Summary of Submissions
Proposed Aged Care Accommodation, Alterations and Additions to existing buildings (Additional 80 beds).
Public Comment Period: (January 3) 2018 to (April 30) 2018

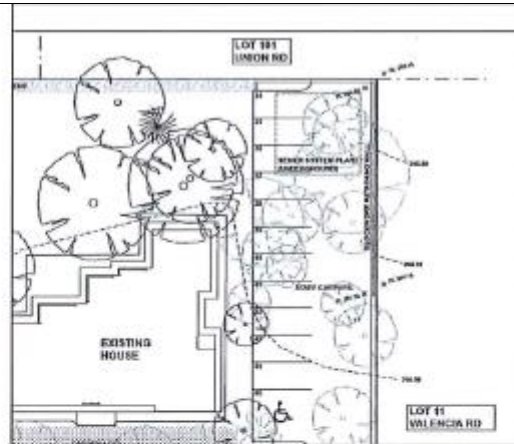
- The delivery area and car park area "B" are located immediately along the boundary with Lot 10 and Lot 11 on the south-eastern side of the development site (Figure 1).
